**Subject: Orcutt Key Site 3 Project, Final Subsequent Environmental Impact Report (SCH #2014061015)
Revision Letter
Assessor's Parcel Number 129-151-026
Project Case No. 13GPA-00000-00005, 13RZN-00000-00001, 13TRM-00000-00001, 13DVP-0000-00010**

Orcutt Key Site 3 Project
Final Subsequent Environmental Impact Report
Revision Letter

SCH #2014061015
Project Case No. 13GPA-00000-00005, 13RZN-00000-00001,
13TRM-00000-00001, 13DVP-0000-00010

Figure 1 Revised Site Plan

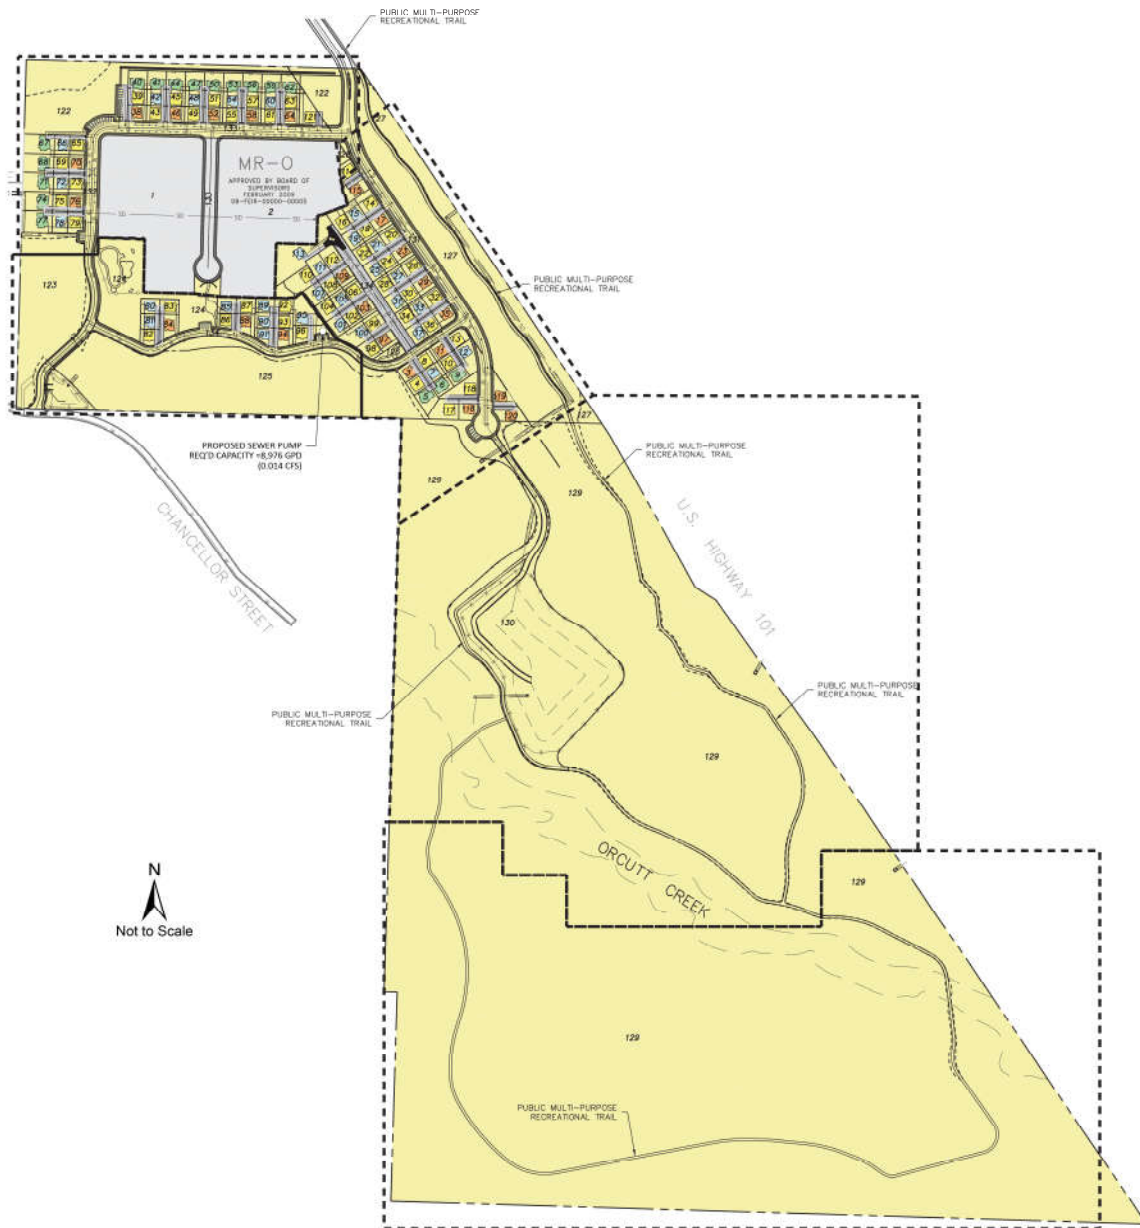
The proposed modifications to the Orcutt Key Site 3 project include a reduction in the original project development footprint along the U.S. Highway 101 (U.S. 101) corridor and in the northwestern corner of the project site. The development footprint reduction creates a landscaped buffer between the residential development area on the project site and U.S. 101. Single-family residential units proposed east of “Road A” would be eliminated or redistributed on areas west of “Road A,” for a net reduction of six units and four lots; one lot would be re-designated for roads and one lot would be re-designated for open space. Minor site plan changes would be made to provide a 200-foot minimum setback (or buffer) from the edge of the U.S.101 right-of-way. The reduction in lots would also allow for a reduced development footprint and distribution of residential units farther from the gully in the northwestern corner of the property.

Overall, these modifications would result in a 6-unit reduction from 125 units as originally proposed to 119 units, and would reduce the number of lots in the proposed VTTM from 138 to 134 lots. The 14 homes located on the project perimeter adjacent to the existing mobile home park to the north and single-family homes to the west would be single-story homes. The remaining 104 homes would be one- and two-story homes ranging in size from about 1,100 square feet to 1,610 square feet. The amount of open space on the project site would increase from 106 acres (76%) to 113.5 acres (82%). Additionally, average building height in the interior

portion of the mesa may increase as a result of more units being proposed as two-story to provide the proposed 119 units within the reduced development footprint. The revised site plan is shown in Figure 1 and the revised project development footprint relative to the project site is shown in Figure 2.

Figure 2 Reduced Development Footprint

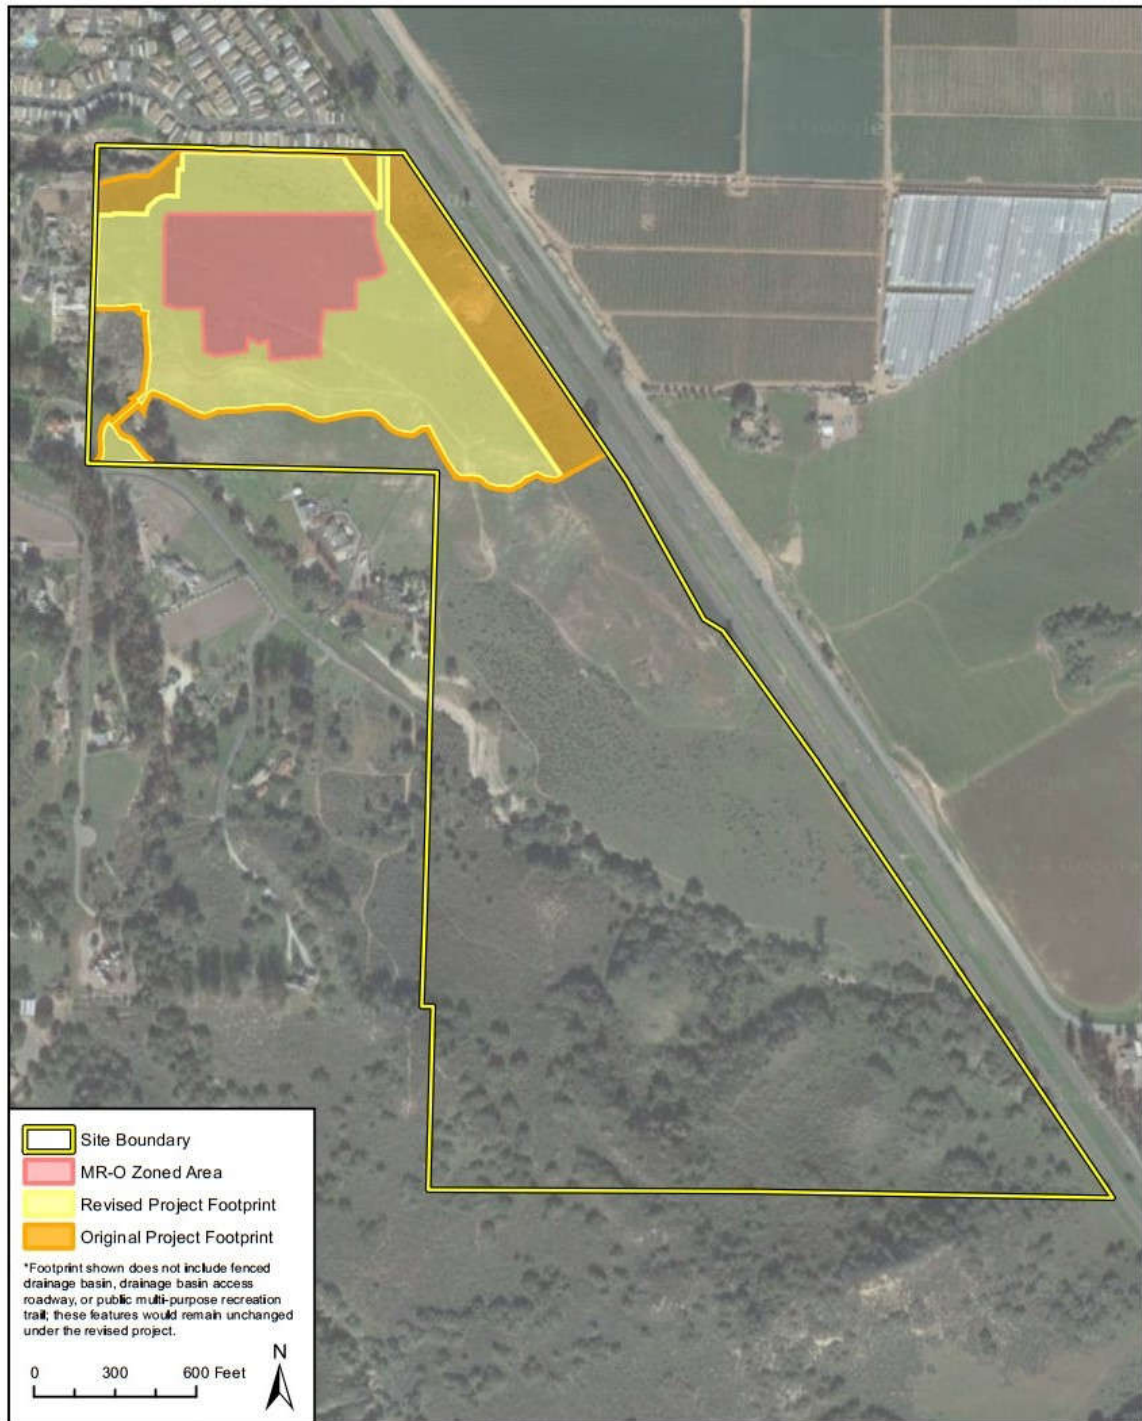
The increased setback along U.S. 101 and from the gully in the northwestern corner of the site would preserve an additional 7.5 acres of open space on the site, reducing biological impacts as compared to the original project. As with the original project, the revised project would avoid portions of the site that contain sensitive habitat, but would remove non-native grassland in the northern mesa area, which is comprised primarily of non-native annual grassland that is not considered to be sensitive habitat. The revised project would result in reduced acreage of non-native grassland removal as a result of the 200-foot setback along U.S. 101 on the northern mesa area. As described in Section 4.3 of the Final SEIR, Biological Resources, the project would impact 0.02 acre of Central Dune Scrub, and 0.12 acre of Central Coast Live Oak Riparian Forest (refer to Table 4.3-6 and Figure 4.3-2). The proposed utility easement location along Oakbrook Lane, would not intersect with either of these habitat types, and would therefore not change the level of potential impact. The revised project would result in similar impacts to these sensitive communities. The list of special status species that could potentially be affected by the project remains consistent with the special status species evaluated in Section 4.3 of the Final SEIR (refer to Table 4.3-3 and Table 4.3-4 of the Final EIR).

Figure 2-3

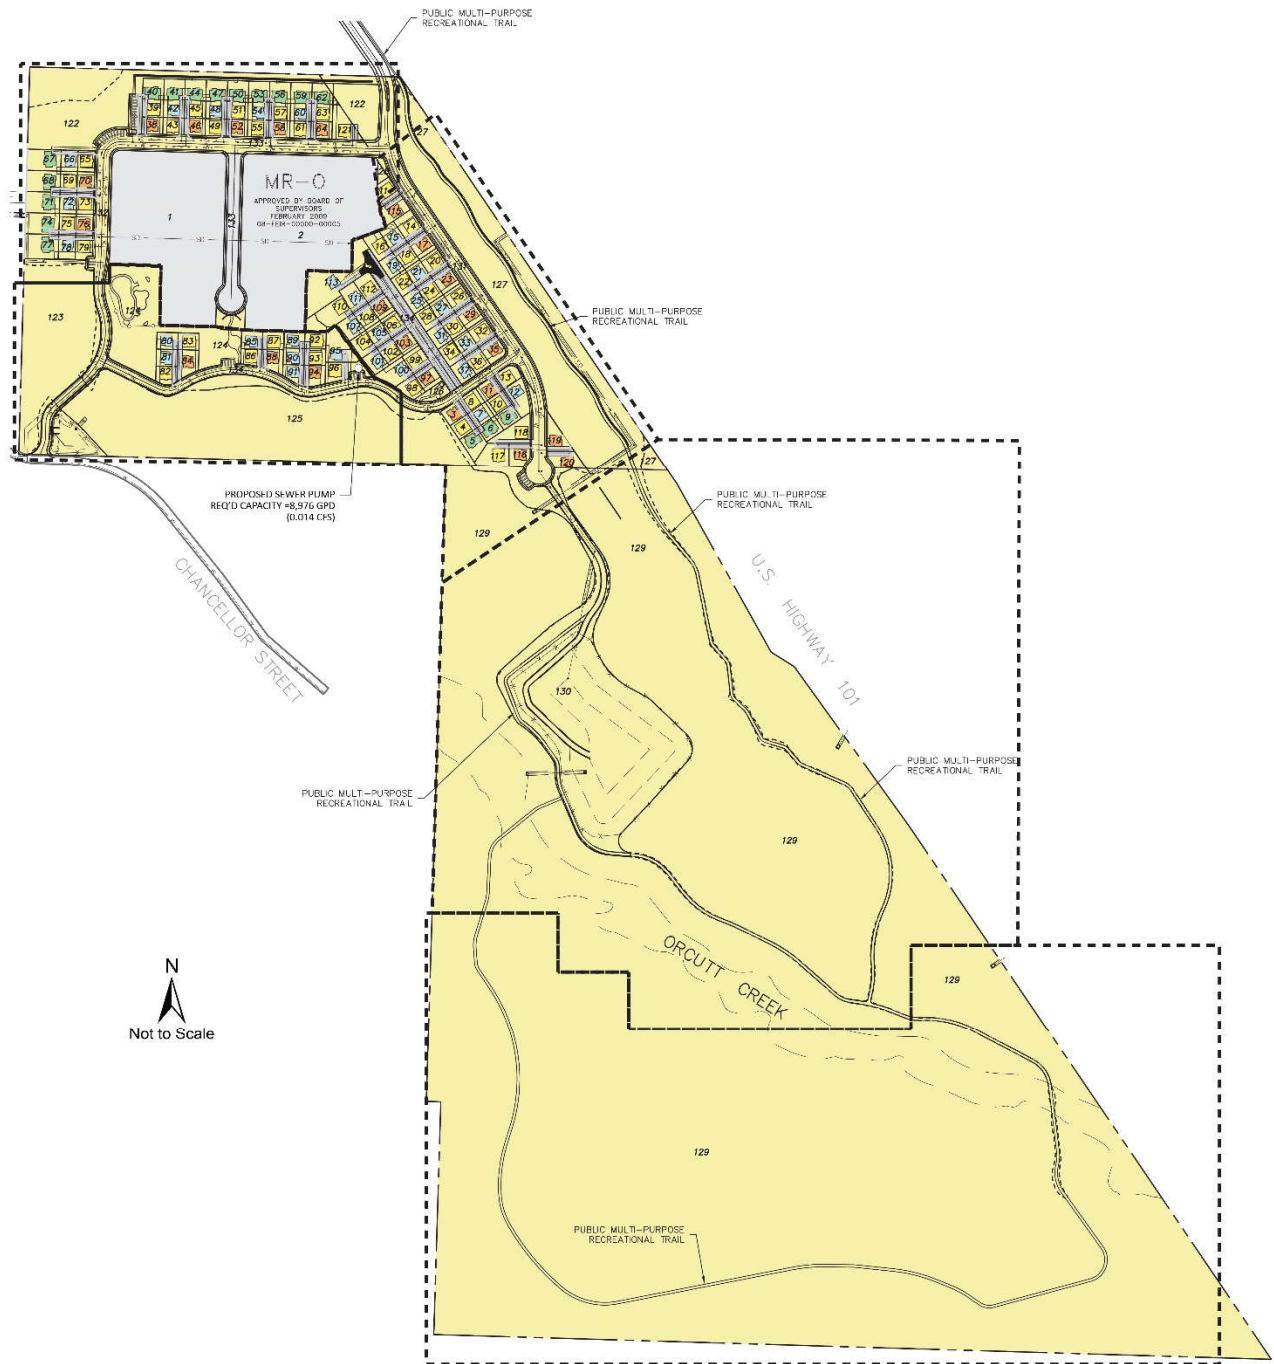
proposed project evaluated in this SEIR. The project proposes to develop ~~125~~ **119** single-family units ~~in a variety of~~ **with a small lot detached cluster home** product (~~small lot, detached cluster homes, and larger single family residences~~) on the northern portion of the site. Figure 2-3 illustrates the preliminary site plan, as well as the MR-O designated portion of Key Site 3. Landscaping, including street trees and an entry monument at the primary entrance to the development, is proposed, as are decorative street lights. In addition, approximately ~~106~~ **113.5** acres (~~76~~ **82**%) of the site is proposed as open space. The open space area includes the upper mesa bluff area, Orcutt Creek, private parks and trails, public multi-use and hiking trails, landscaped basins, and natural and restored habitat on hillsides and along the creek.
